PCN-20210114 TE0600-03 DDR3 Change and Product Update

Company	Trenz Electronic GmbH
PCN Number	PCN-20210114
Title	TE0600-03 DDR3 Change and Product Update
Subject	BOM change
Issue Date	2021-01-25

Locate DDR3 RAM (U6, U7) on top side of PCB:

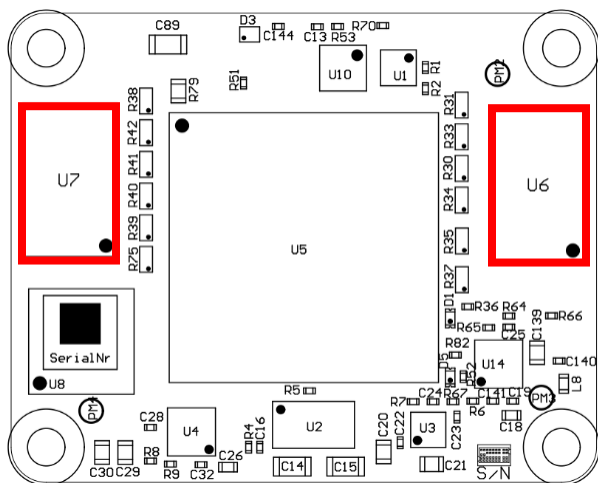
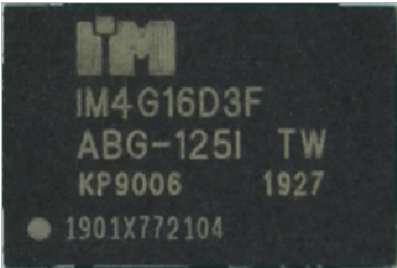
#1 Change DDR3 RAM from IM4G16D3FABG-125I to IS43TR16256BL-125KBLI

Reason: Component is end of life.

Impact: New DDR timings may be considered in designs.

old	new
IM4G16D3FABG-125I	IS43TR16256BL-125KBLI
